PCN# 20230205000

Resolution of First Article Inspection Issues

MitySOM-AM62 Modules

Title: Resolution of issues encountered on FAI units.

Figure 1 MitySOM-AM62 Pin 21 configuration, Revision -1 Variants

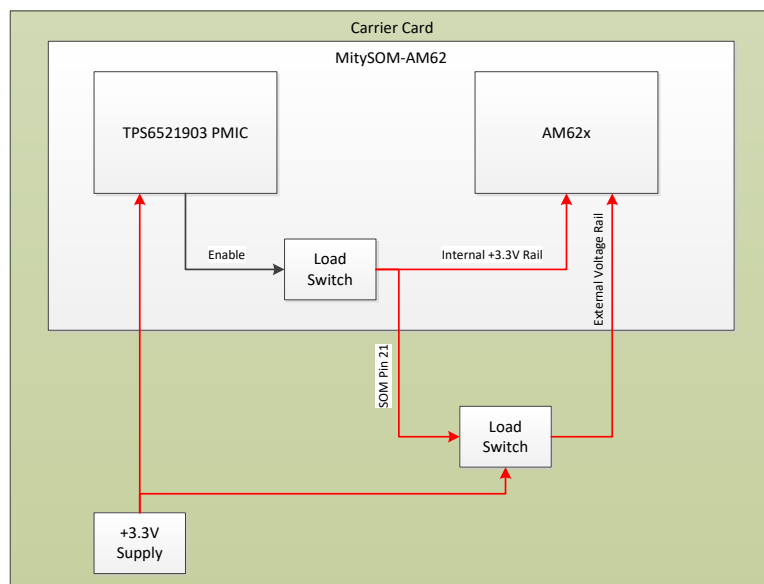
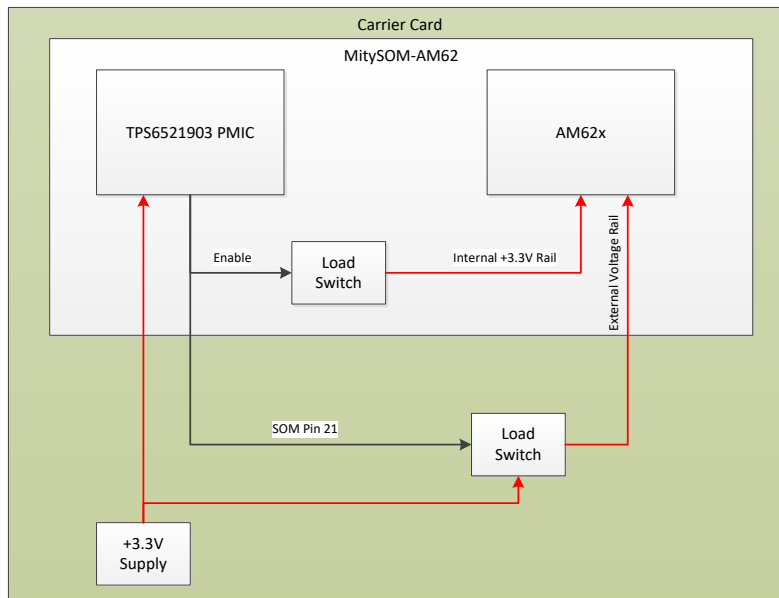
The revision 1 variant of the SOM provides a +3.3V output from an on-board load switch on Pin 21 of the edge connector that was intended to provide a sequenced voltage output or voltage output enable for the carrier cards in order to meet the AM62x processor power rail sequencing requirements. This is shown in Figure 1. The local +3.3V IO output is used on multiple IO rails on the AM62x. The signal presented to the external pin has been changed to be the load switch enable signal instead of the load switch output, as shown in Figure 2.

During module power down testing (via command from the module software), a leakage path was identified from the external +3.3V supply rails passed to one of the AM62x IO supplies back to the local +3.3V IO power domain via the AM62x processor. This leakage would cause the output voltage to be held higher than a typical shutdown voltage threshold, and the result was the external +3.3V load switch circuit (in this case, on the Development Kit board) would not power down as expected. To ensure a proper power down sequence, using the enable signal from the PMIC directly routed to the external power switch ensured proper shutdown.

With this change, it should be possible for the MitySOM-AM62 to properly shut down all external supplies connected to the processor (given the carrier card honors the enable signal presented on Pin 21). However, Pin 21 may no longer be used as a sequenced supply. Any carrier card requiring external +3.3V IO voltages connected to the AM62x bank pins of the MitySOM-AM62 will require an external load switch circuit as shown. See the MitySOM-AM62 development kit schematics for an example circuit to accomplish this.
